KING'S MARK ENVIRONMENTAL REVIEW TEAM

DUNHAM POND PROPERTY

NEW FAIRFIELD,
CONNECTICUT

Environmental Review Team Report

Figure 5

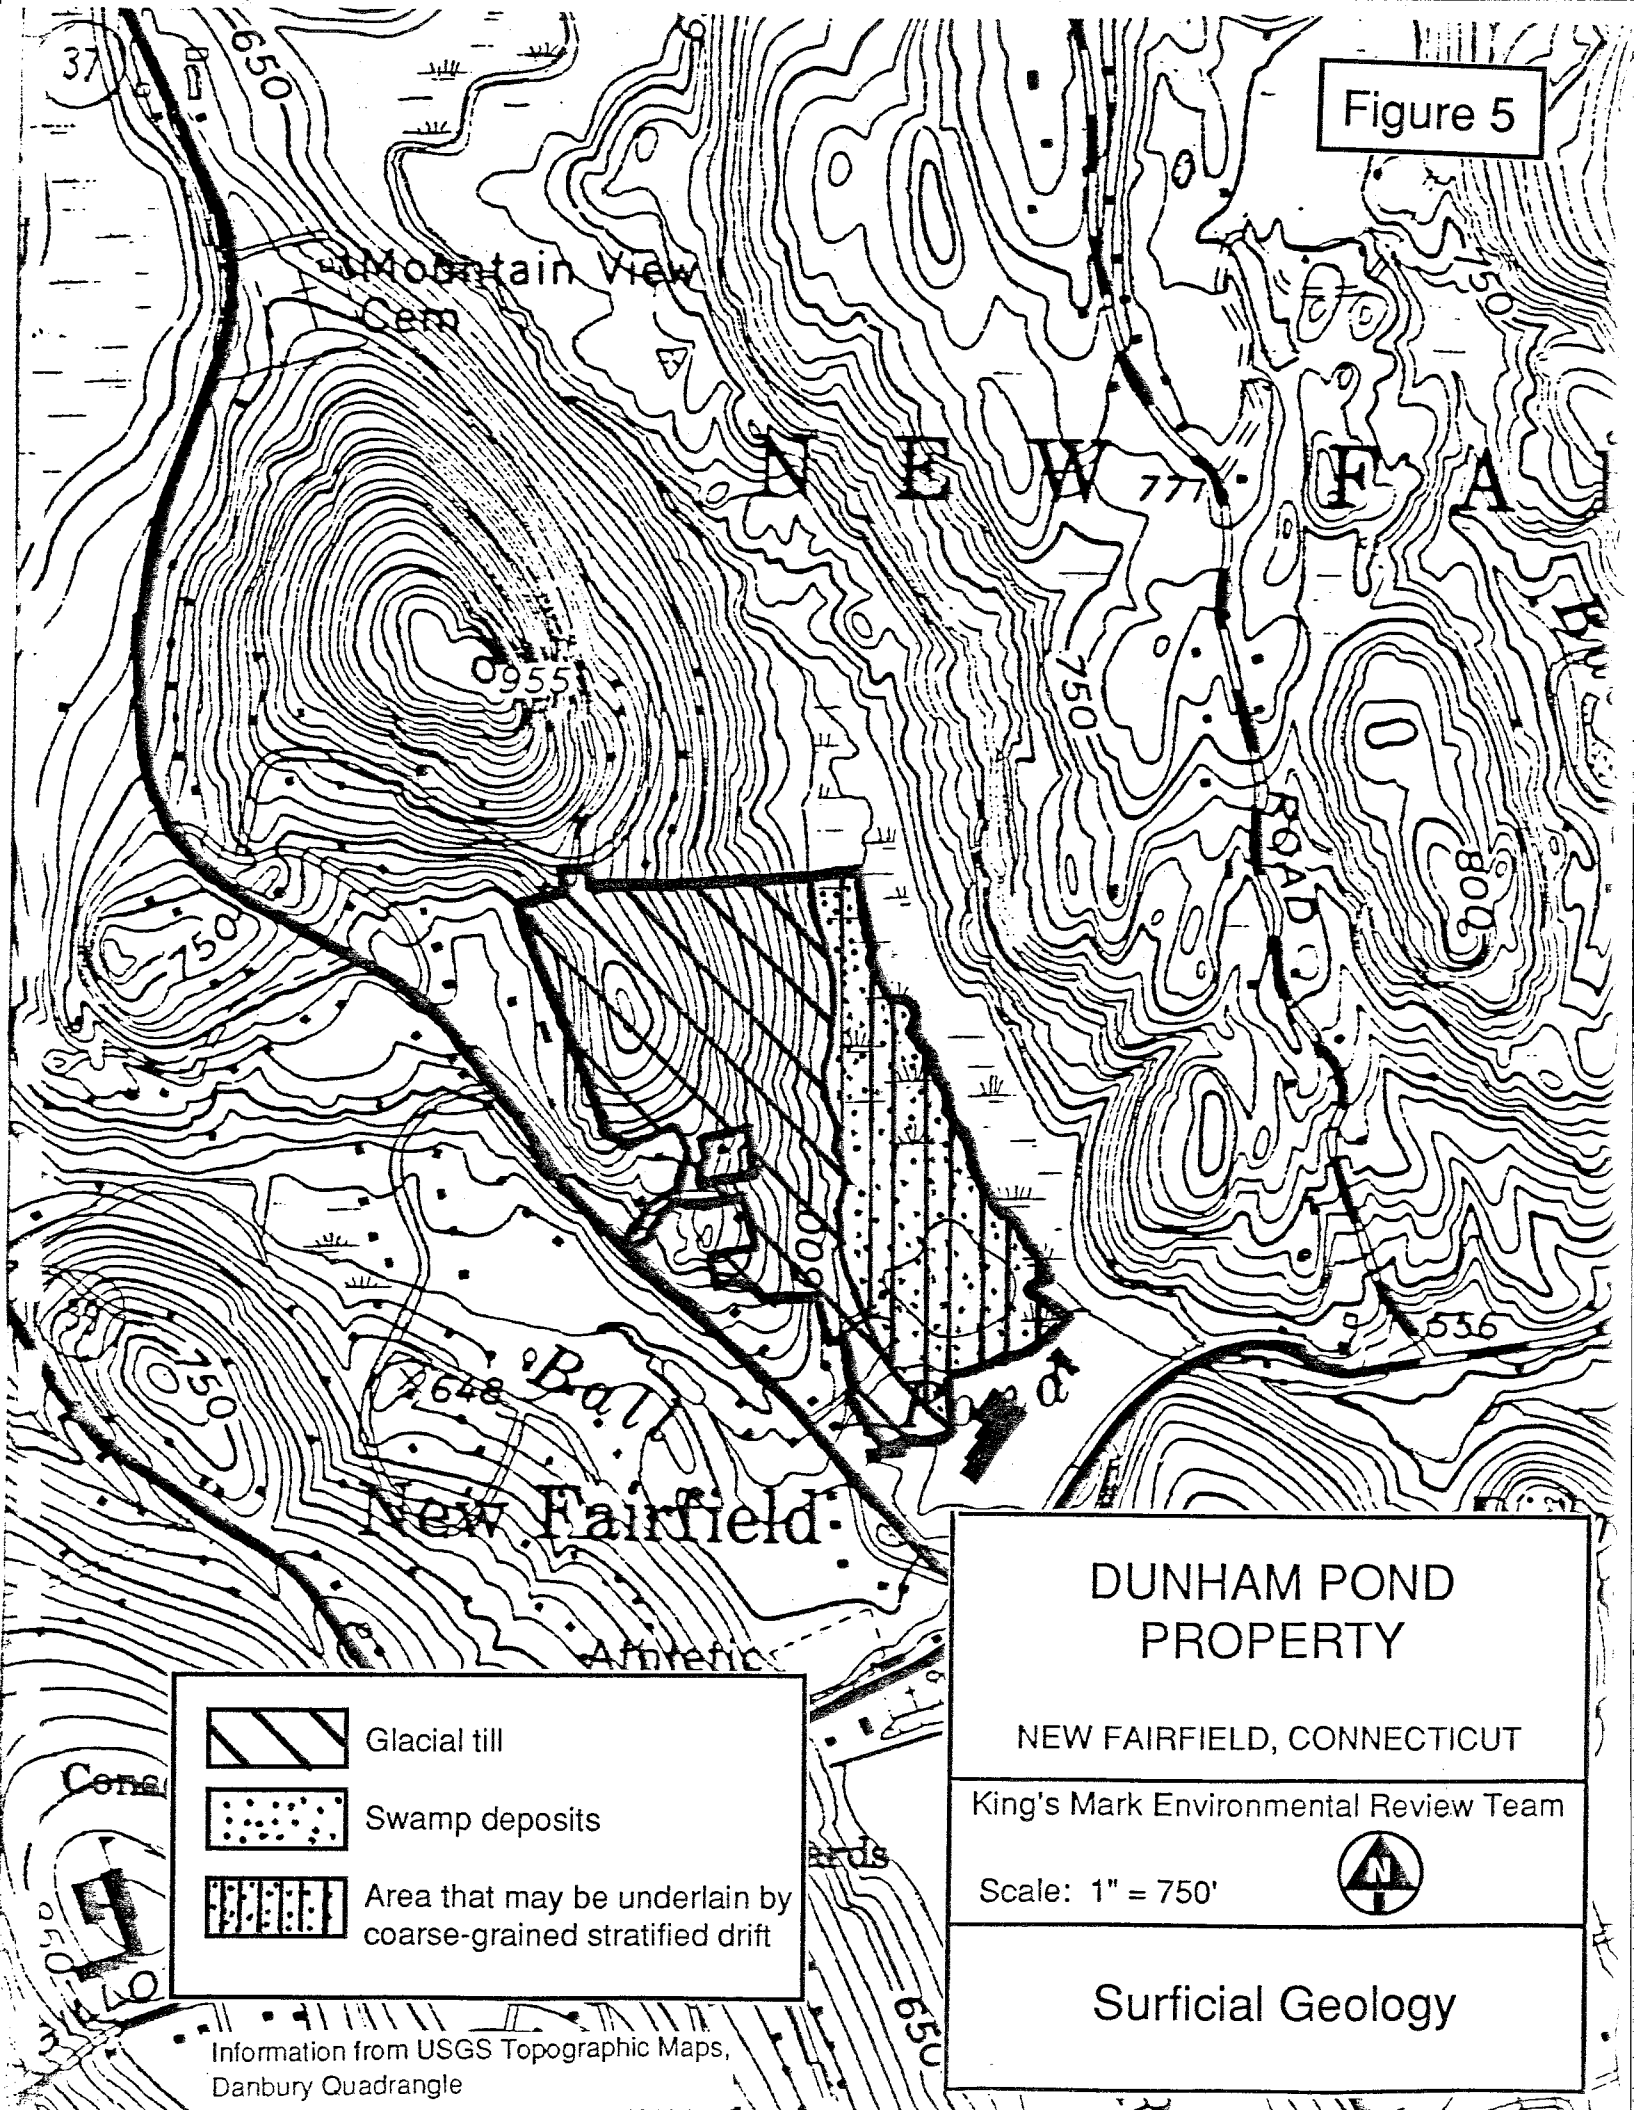
The majority of the site is covered by a glacial sediment called till (see Figure 5). Based on observations made on-site and a review of available hydrogeologic mapping data, the swampy deposits in the eastern parts may be underlain by sandy, gravelly materials that were deposited by melting blocks of glacier ice that occupied the valley. These deposits are called stratified drift.

Stratified drift deposits, mainly composed of permeable sands and gravels, have filled Short Woods Brook Valley on the site. The stratified drift deposits may be as much as 39 feet thick on the site. These deposits may be favorable for water supply wells, but hydrogeologic testing of the aquifer will be required.
